Houston Lighting & Power

June 15, 1988  
ST-HL-AE-2683  
File No.: G9.1, R5  
10CFR50

South Texas Project Electric Generating Station  
Unit 2  
Docket Nos. STN 50-499  
Annotated FSAR Revisions Regarding  
the Revised Unit 2 Cycle 1  
Core Design/Energy Requirements

Attachment: Annotated Revisions to FSAR Chapters 1, 4 & 15  
and affected NRC Question Responses

Figure 15.3-17 B

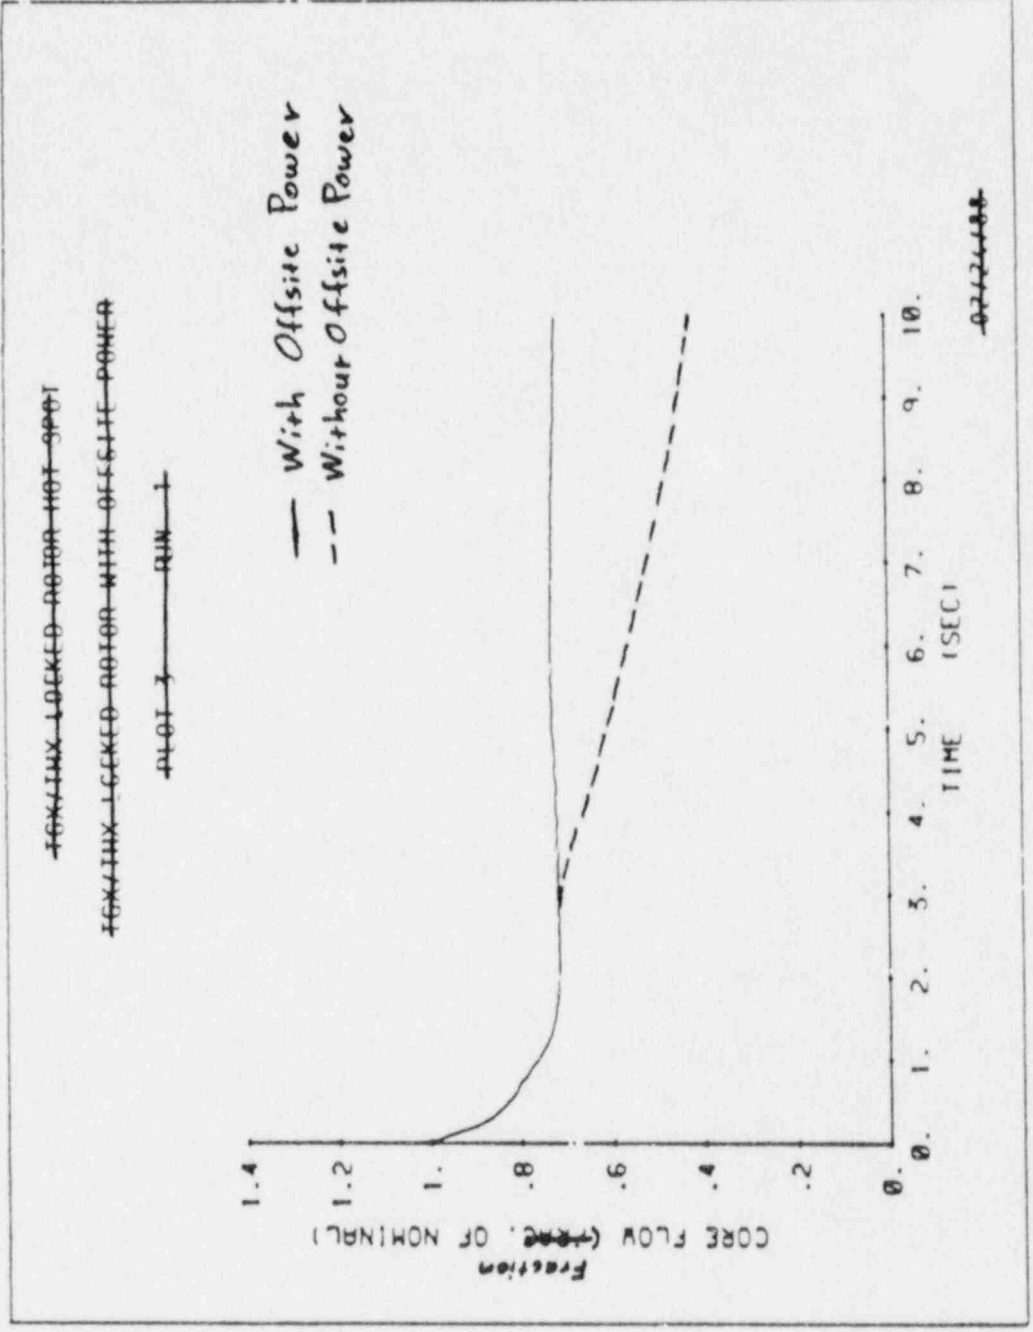
Replace above figures  
with following two figures

Figure 15.3-19 **B**

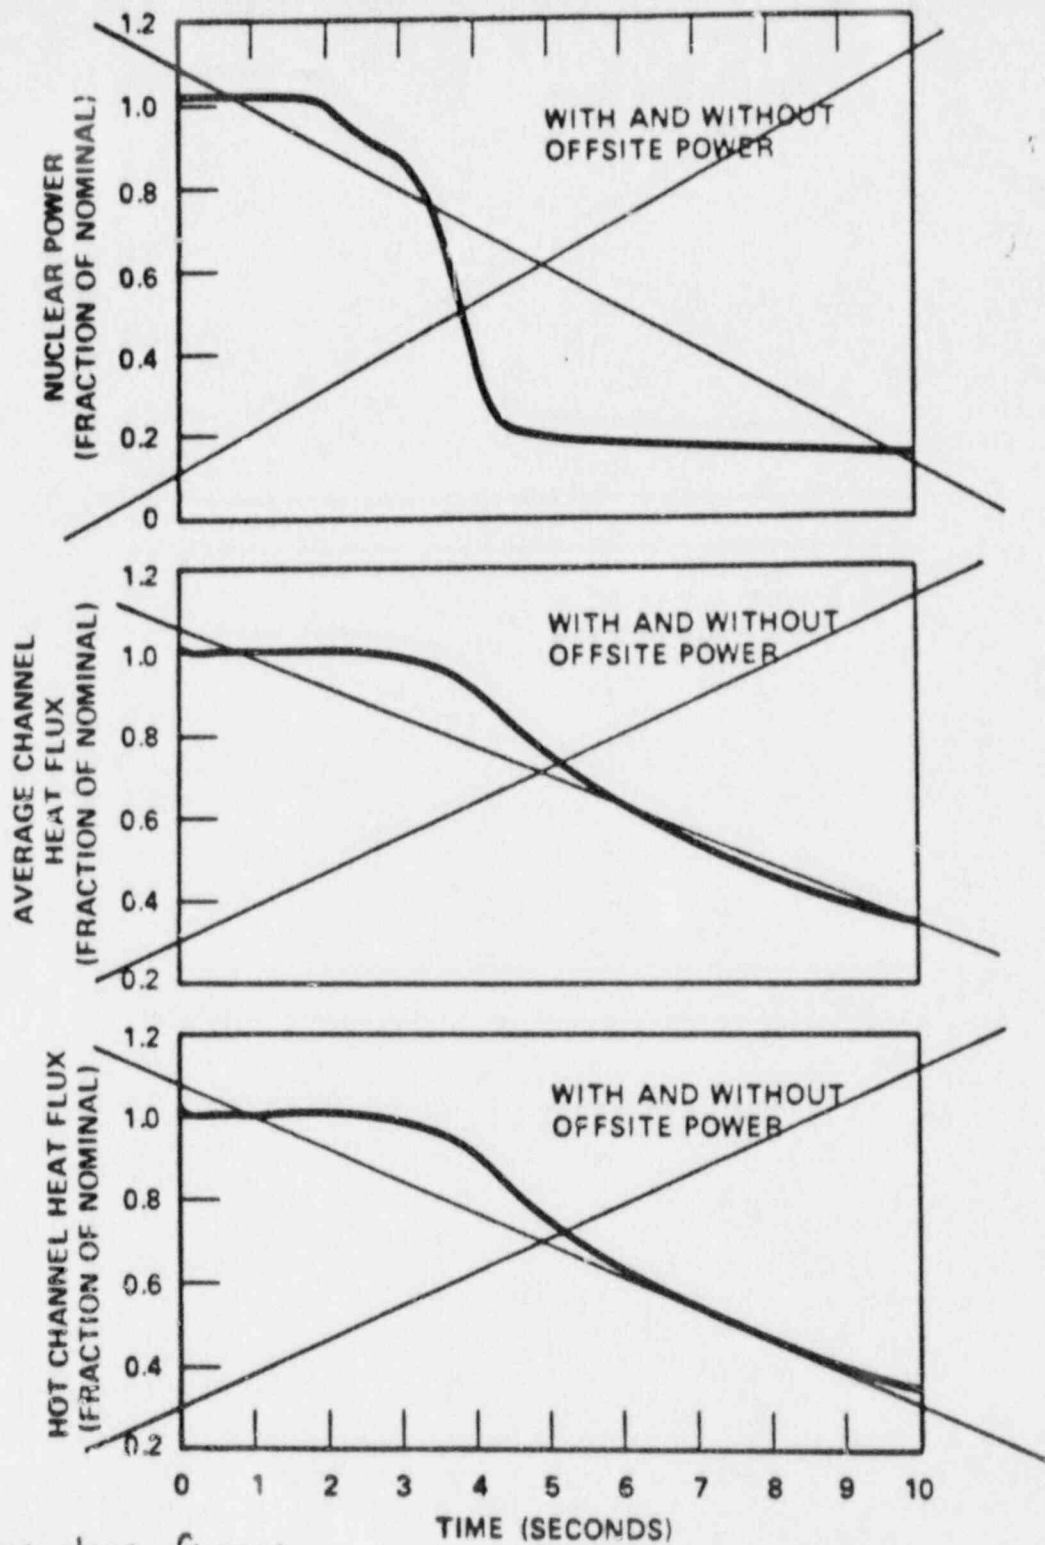
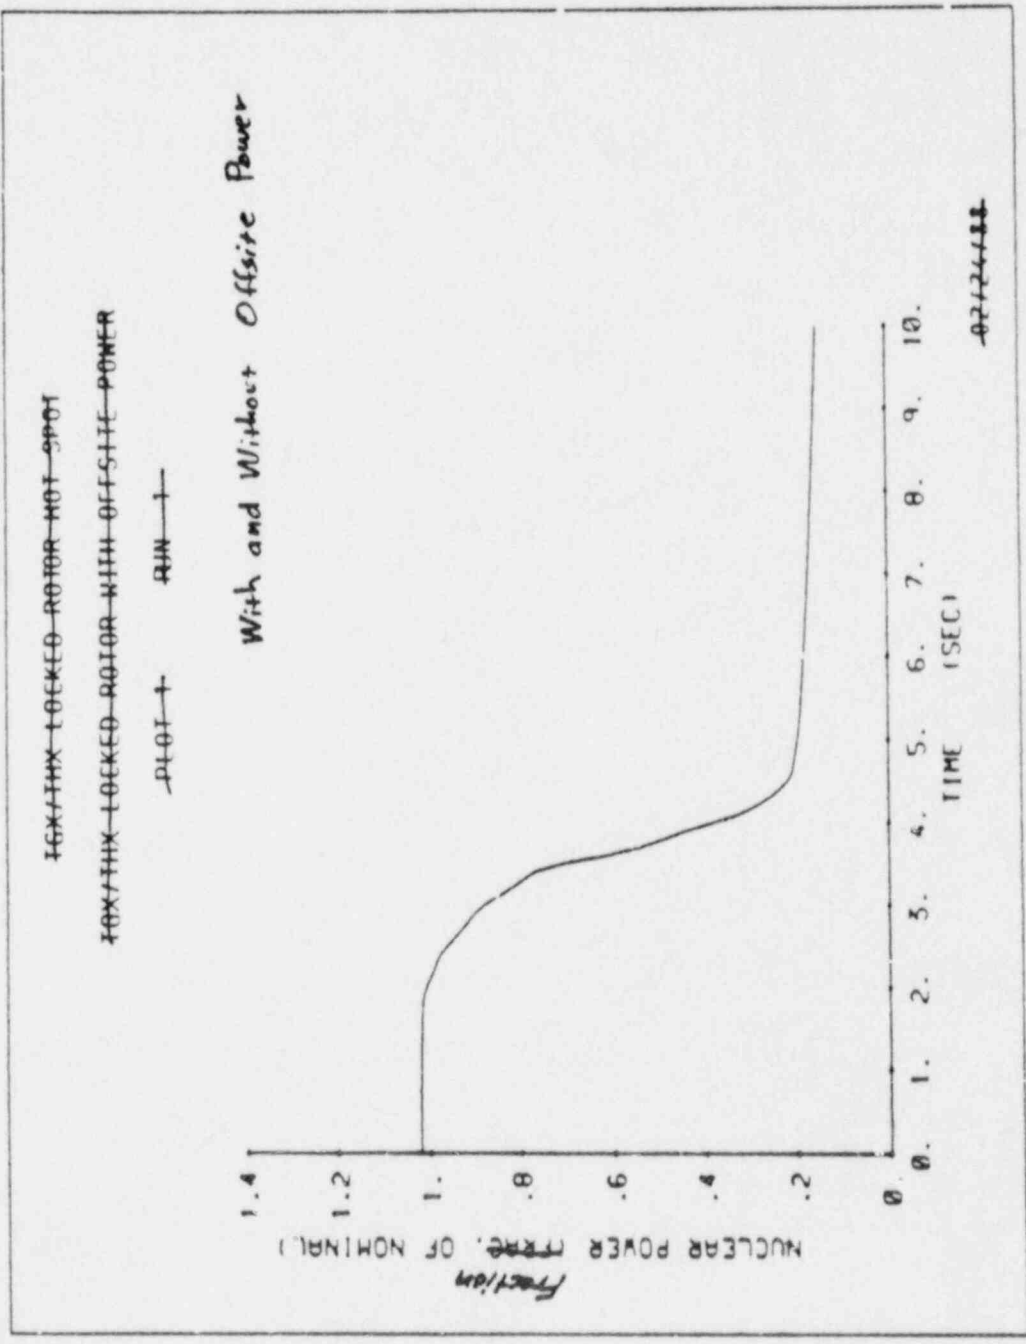
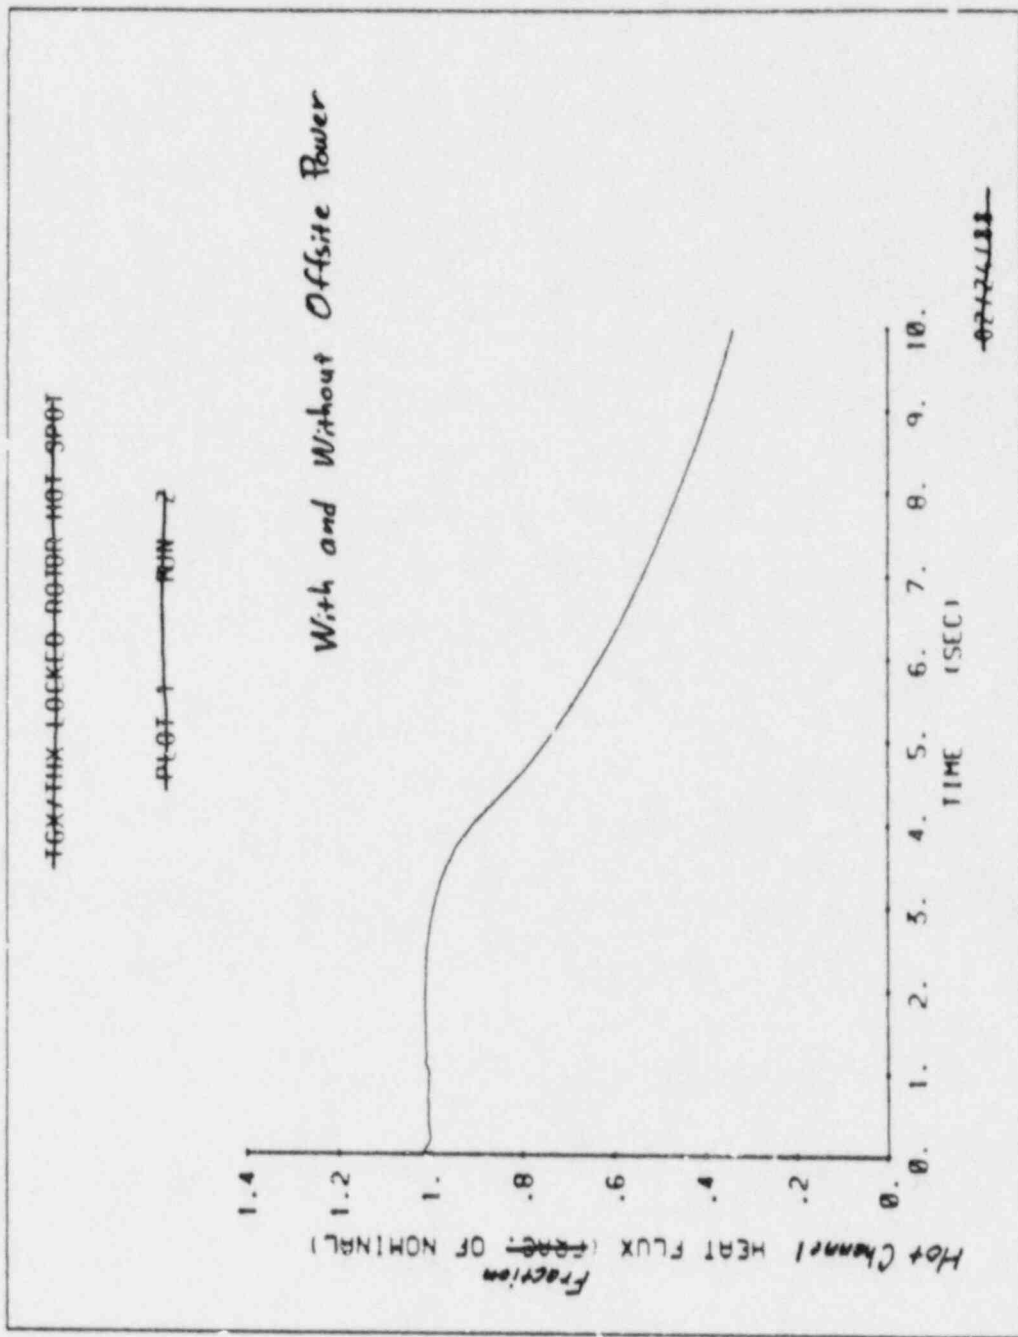
Replace above figures  
with following three figures

Figure 15.4-4 B ~~Amended 67~~

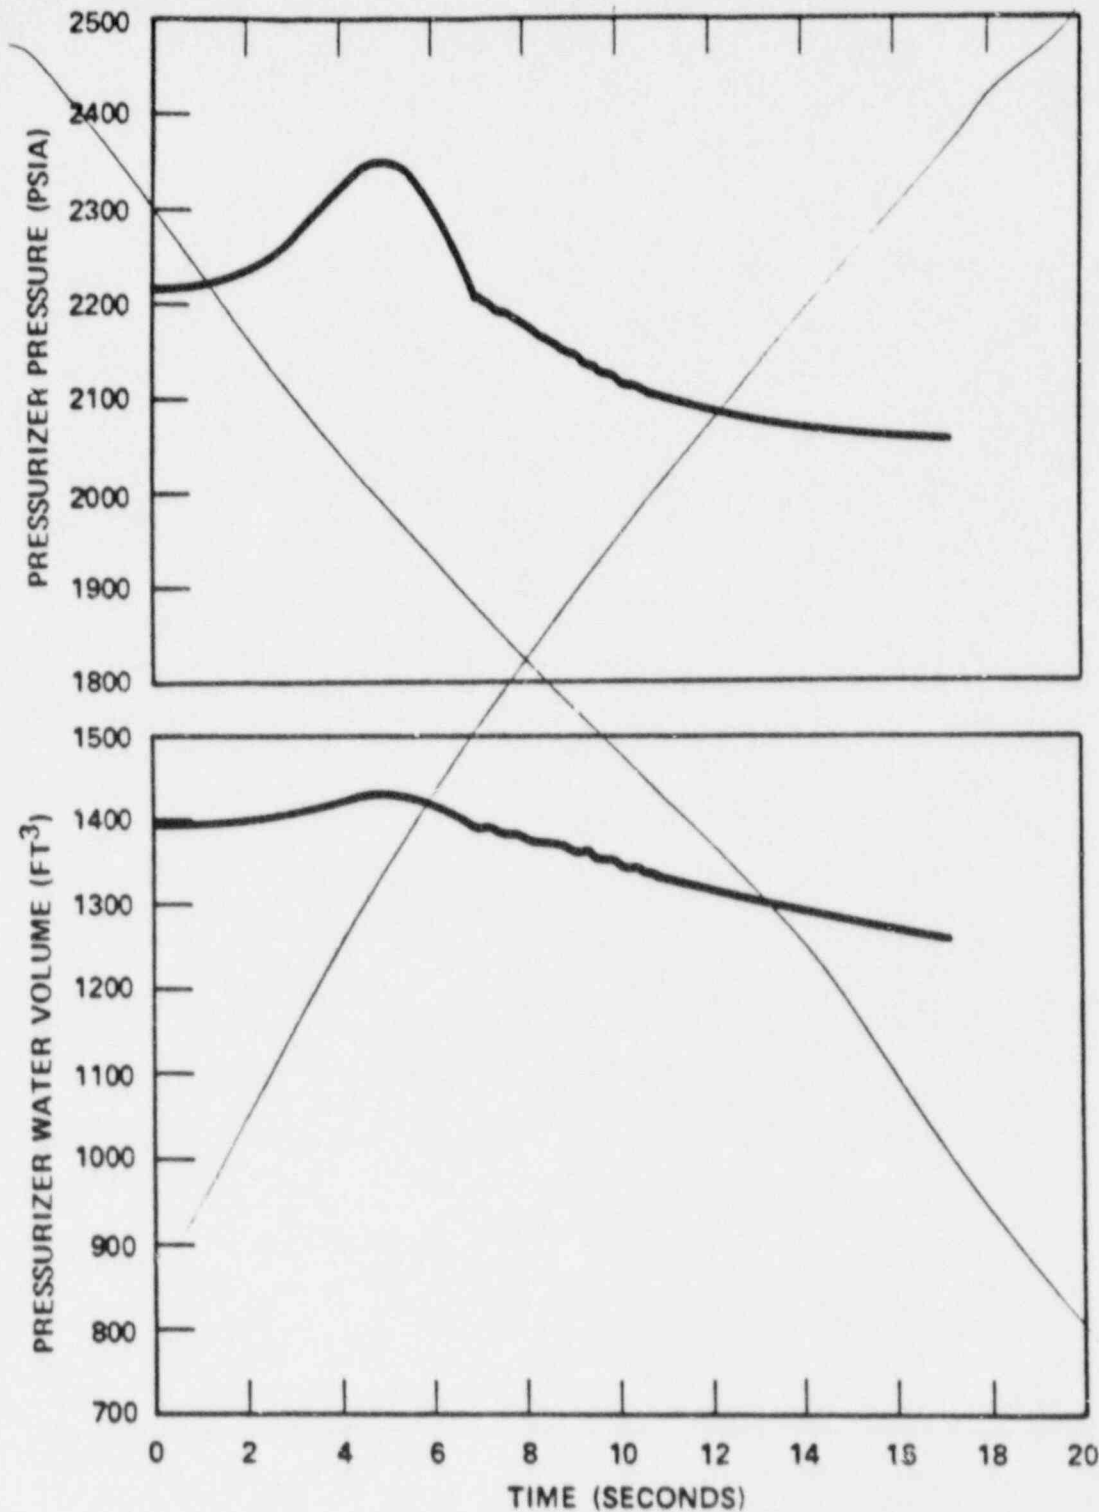
Replace with  
following 2 pages

Figure 15.4-5 A

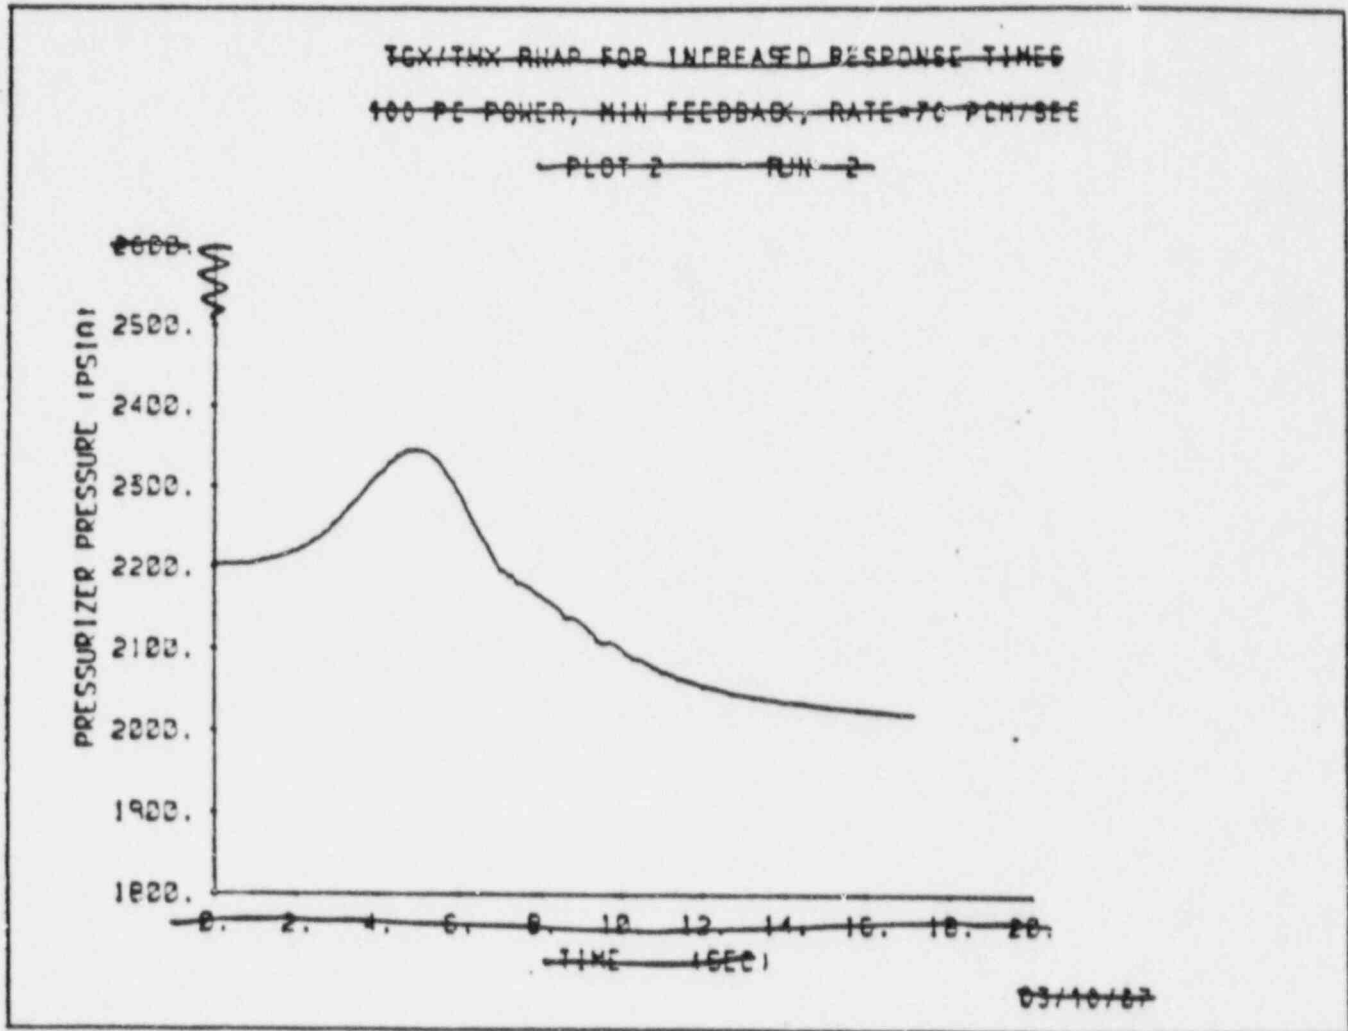
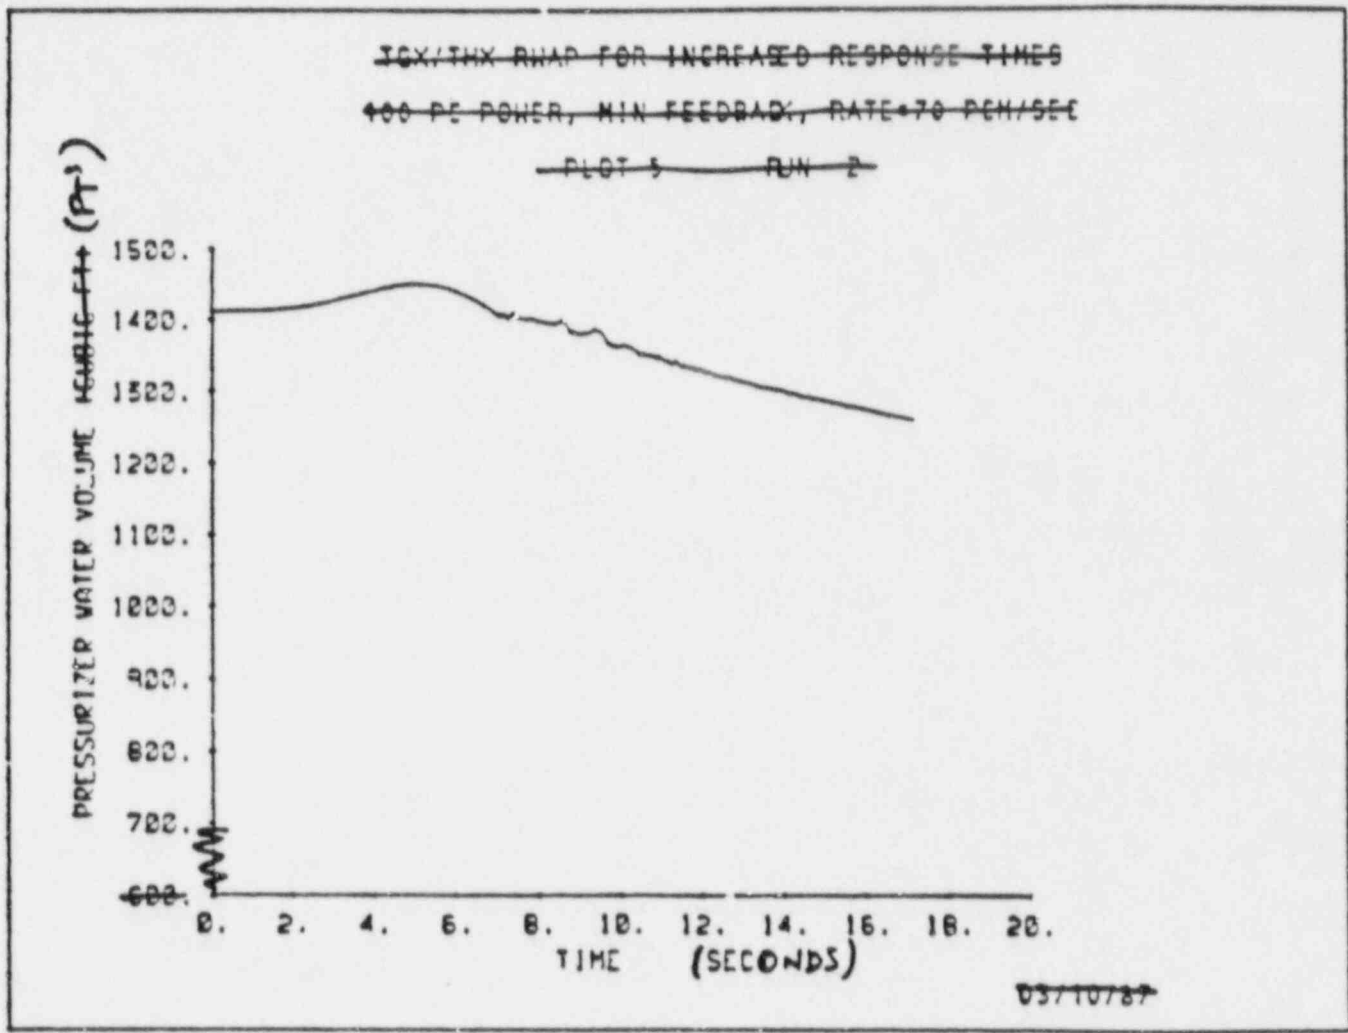
Replacement Figure 15.4-5 A (top curve)

Replacement Figure 15.4-5A (bottom curve)
